DUNE Trolley Designs
William Miller
University of Minnesota
16, September 2020

Phase 2 DSS support structure at Ash River

Access the trolley

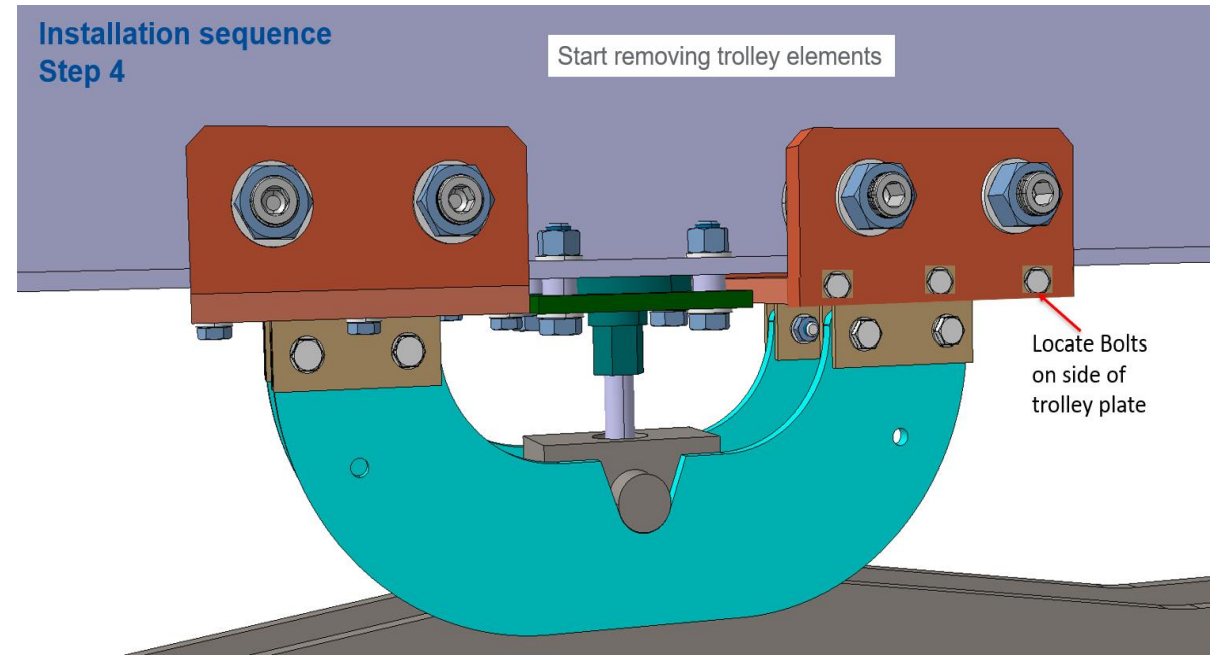
- Access will be difficult with bolts pointed down on trolley. It would be better to locate them on the side ONLY on the accessible side. Use a long bolt into a threaded plate on the back side. That way there is no bolt to remove.
- Have a tie off hole on the back trolley plate so it can be pulled up over the top. All parts need to be on a lanyard.
- Access to APA Hanger important, size of hanger bolt and tread sized to easily lift the load into position.

Removal of ground plane support during cabling

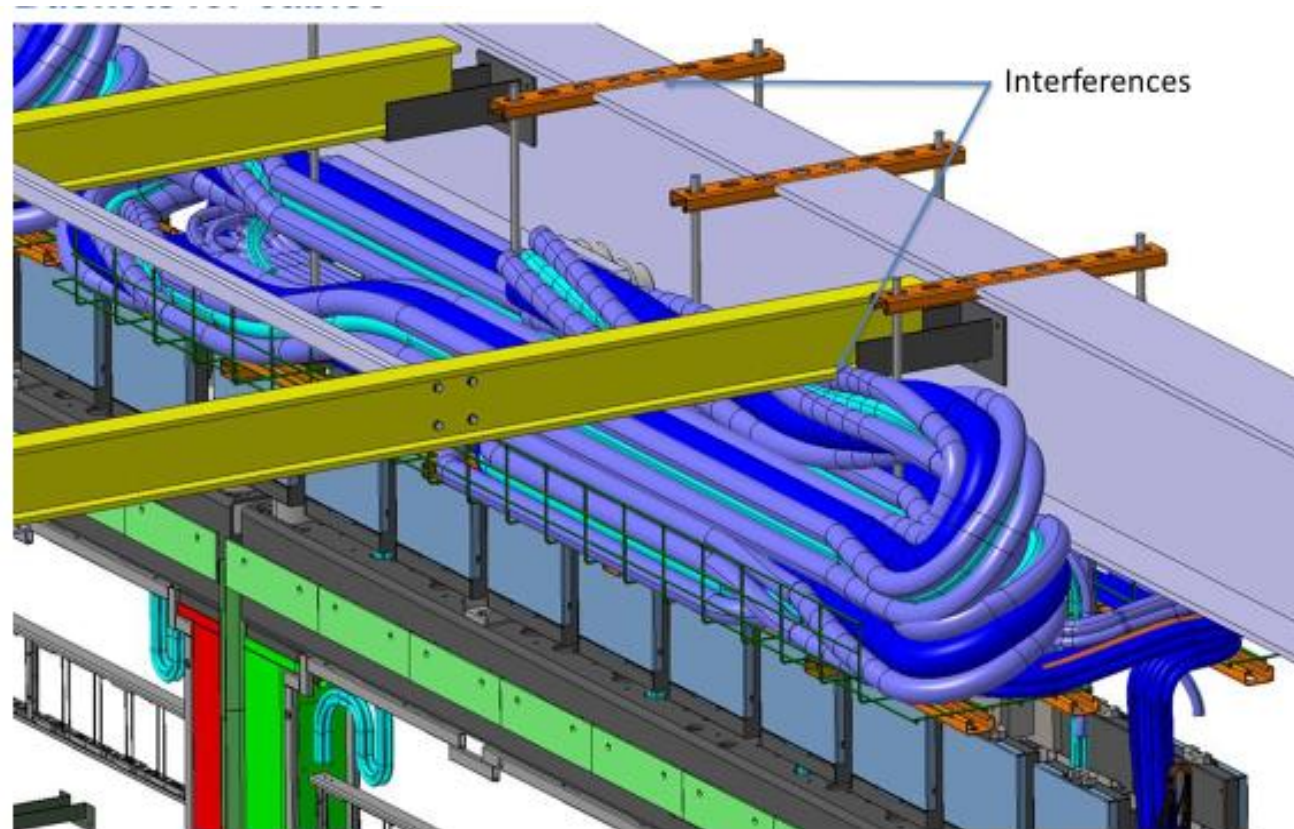
- If the ground plane supports which are fixing the distance between the DSS beams can be removed during the cable process when this would remove some access issues
- We would have to think about the installation sequence. Removing the support beams before the APA goes into position would minimize damage and clearance to the cable trays

Trailing Trolley to support vertical tray

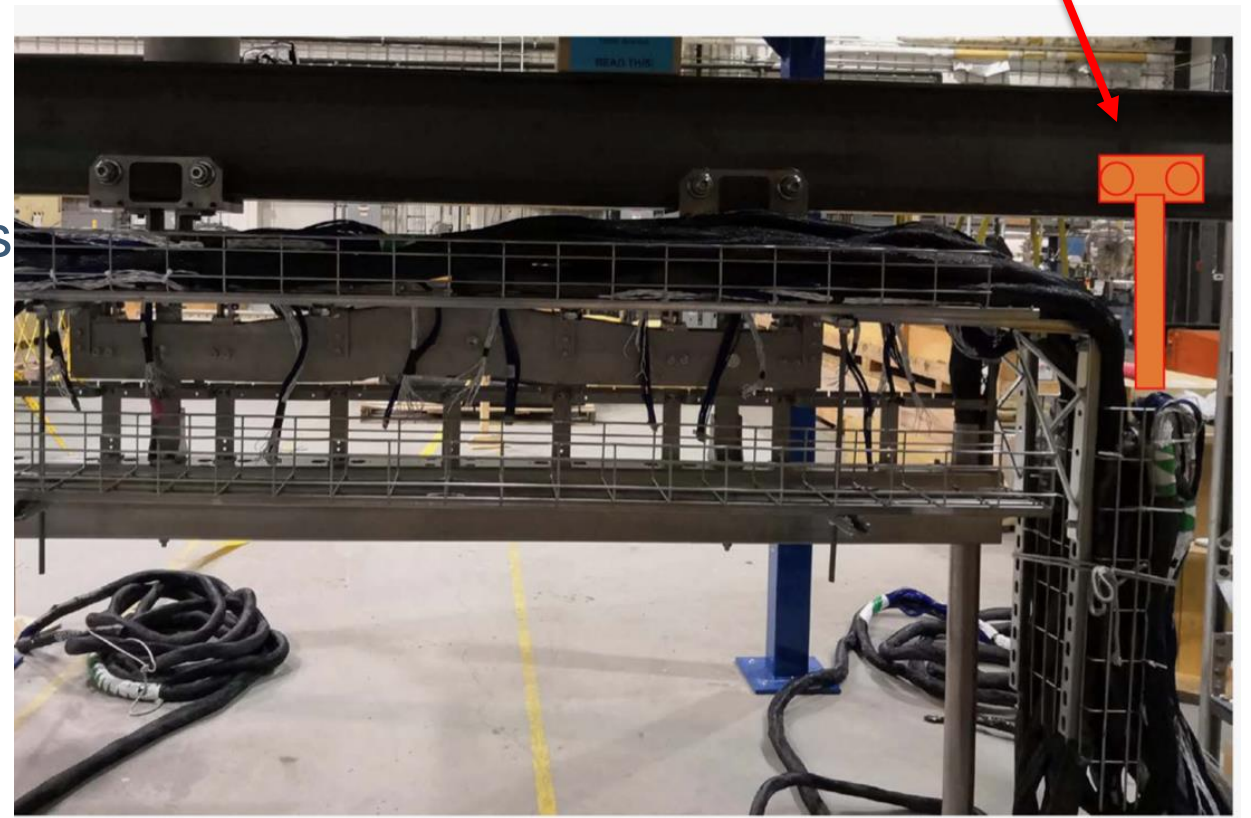
Without a trailing trolley to remove the off balanced cable load the APA could hang out of plane by ~10cm

- It looks like we are moving in the direction of having a trailing vertical cable tray to manage the cable that goes into the feed-thru.
- The load would be on a separate trolley, but it would also be secured to the APA via 10mm Rivnut?
- It would be in place during the cold box test and removed as part of the cabling process in the cryostat.

CPA/Slave Trolley

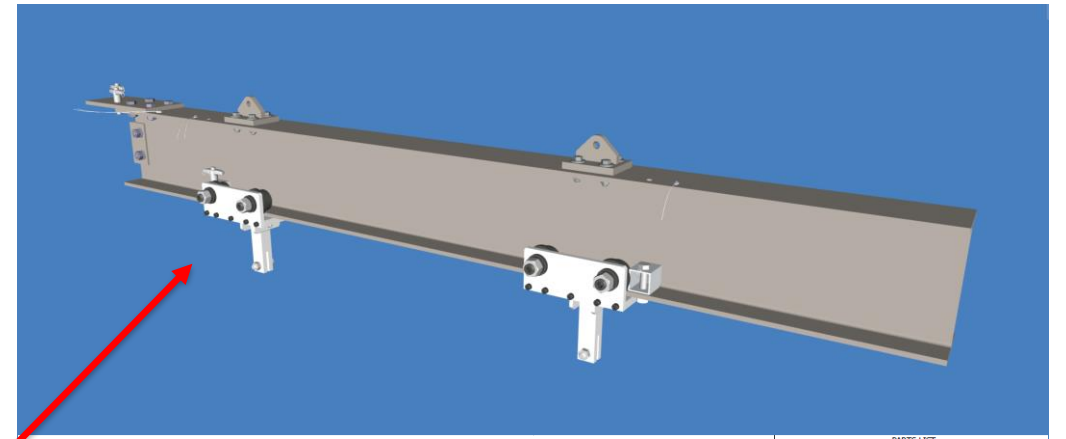
- Current status of the slave trolley (identical to the CPA Trolley except no DSS mounting holes) this is the original design used on the DSS by Vic.
 - It was approved for use during the Phase 1 APA doublet test completed last year.
 - It is getting re-reviewed as part of the updated APA lifting fixture upgrade to allow us to move a completed APA Double to the TCO beam on the Phase 2 DSS support structure.
- We have had several rounds of discussions with Argonne and Giuseppe and expect a completed and approved trolley design by the end of this week
- We have two slave trolleys for the APA Double and Ash River will fabricate two CPA trolleys for the CPA for the DUNE Trial Assembly work.

Shuttle beam trolley design problem

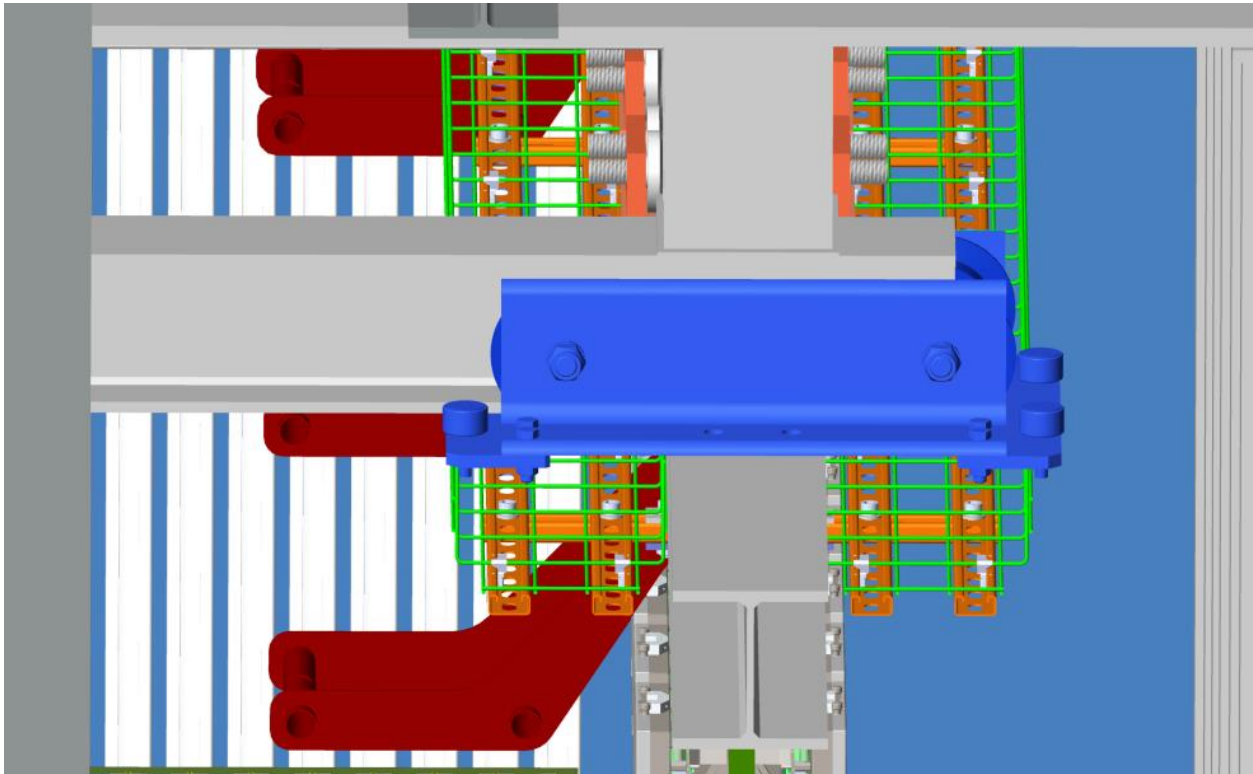
This is an issue that came up at Ash River. Best design practices to minimis racking from AR crane person says that the distance between the wheels and cam followers should be a minimum of 4 times the width of the beam (~24"). **There is already no room for trolley design as is moving the outside DSS beam out 22mm adds to the issue**

Shuttle Trolley missing in v.6 model

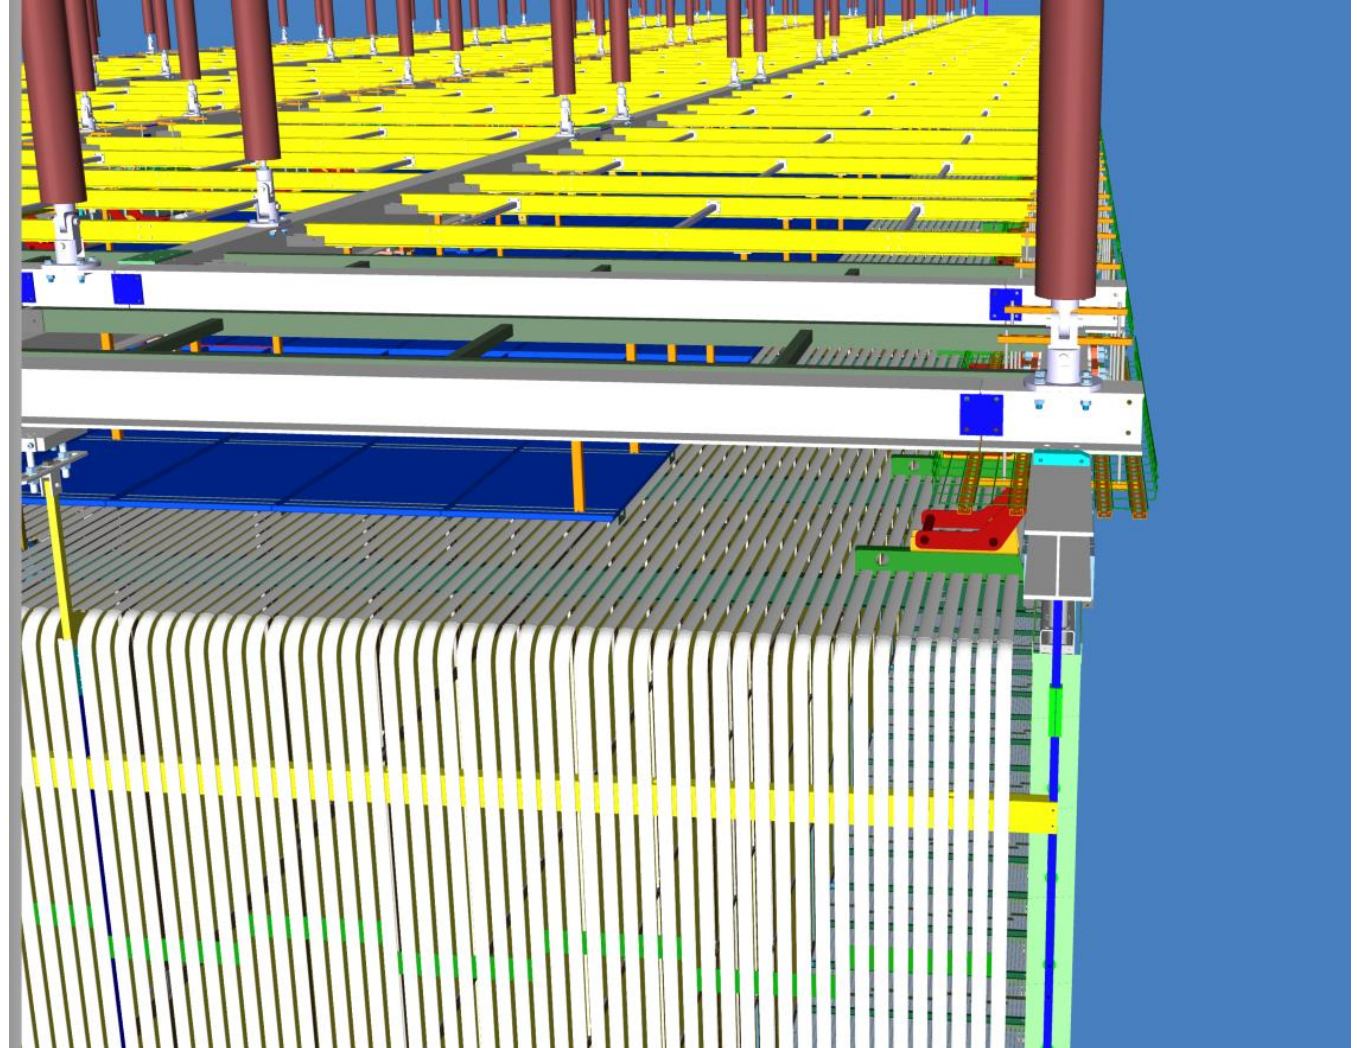
- The issues are the same in the cryostat as it was in Ash River.

Runway beam needs to be extended as far as possible

Length of Top and Bottom FC

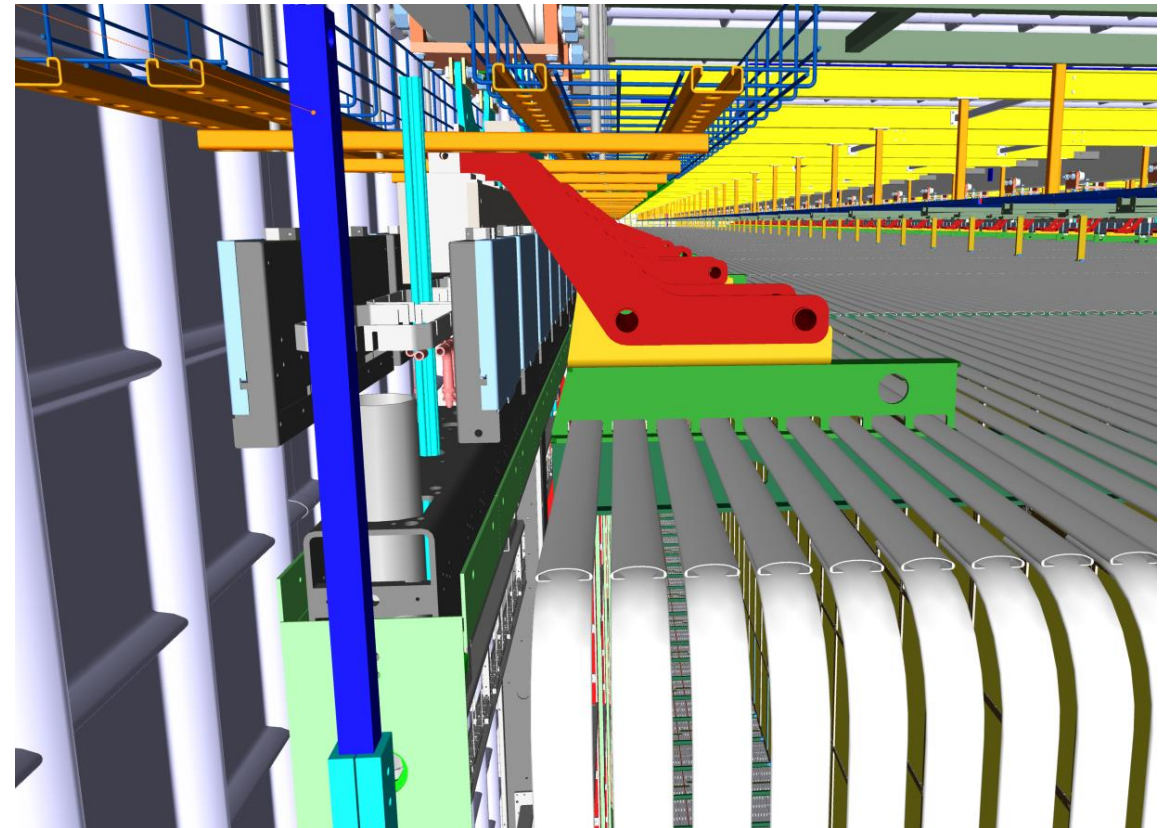
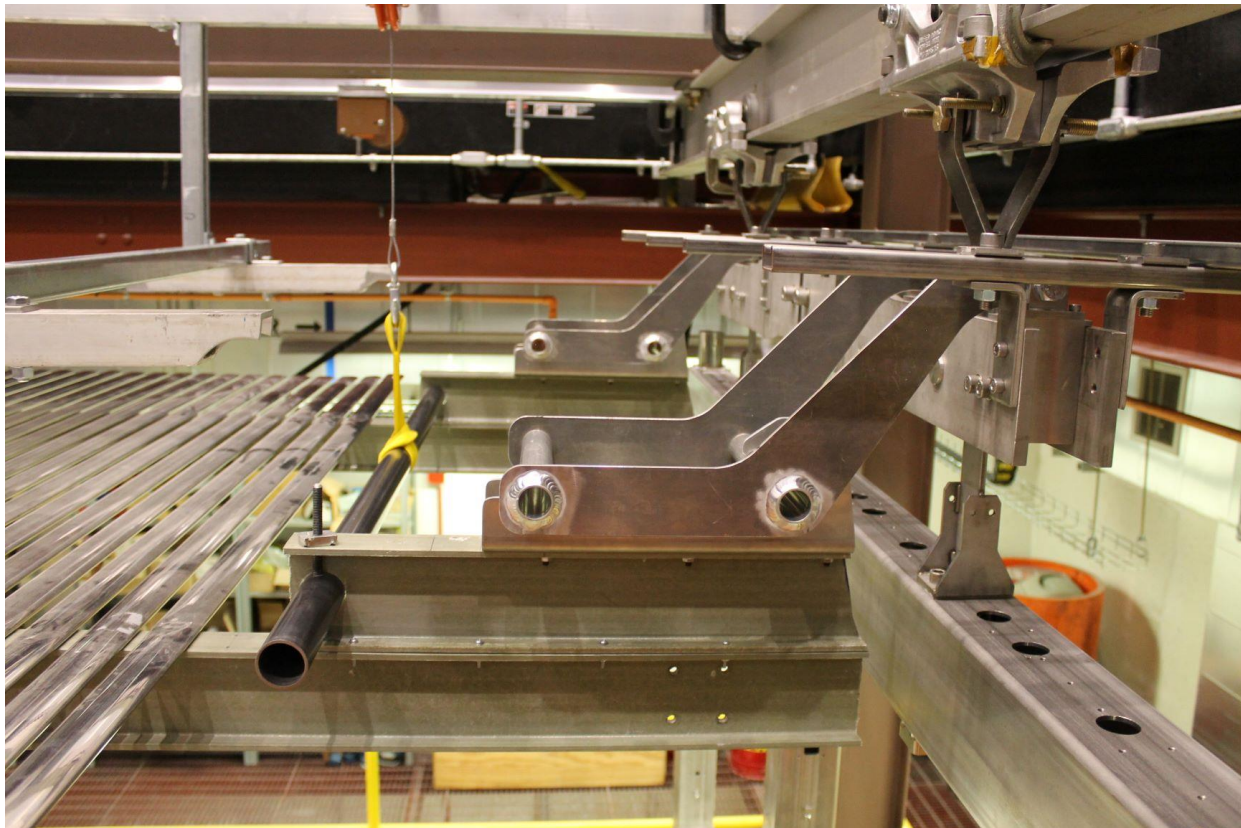
Does the length of the top and bottom FCs and End Walls increase by the 11mm additional spacing between the DSS runway beams? I assume this changes

Clearance of Bottom FC latch

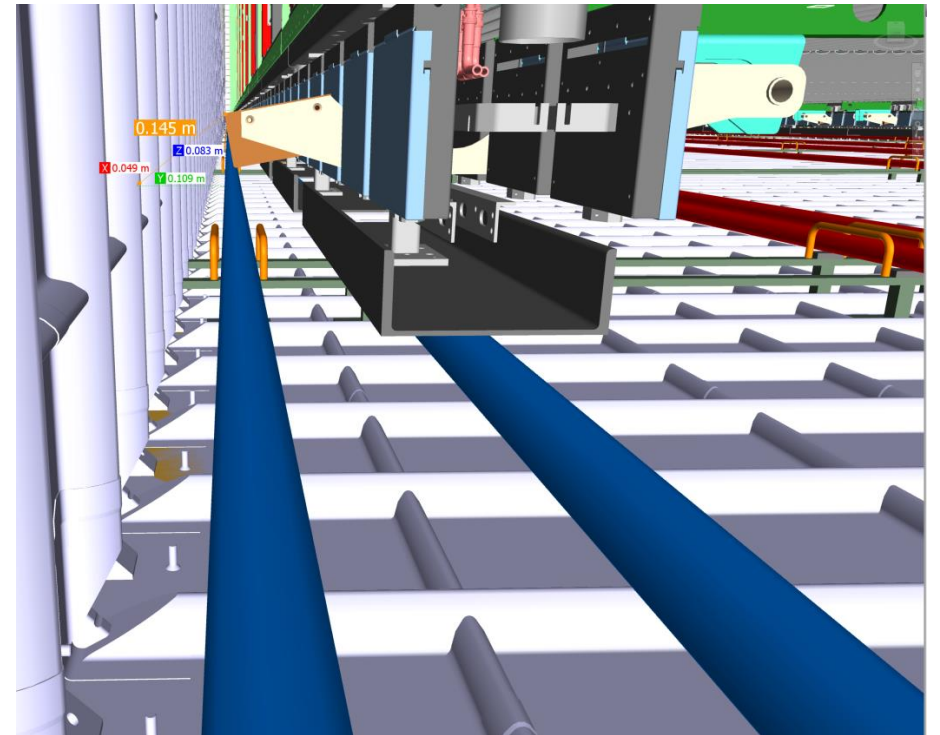
- If the cable tray load is not balanced well at the top the bottom may be at a different position. This is particularly true during transport when the APA is “swinging free”
- Ash River Test during showing potential off set

A load test was performed to understand how much the lower APA deflects if an asymmetric load is placed on the cable trays. A 150lb load was placed on the cable tray after the APA was freed from all lower constraints. The deflection measure was 1” at the middle and 1.5” at the bottom.
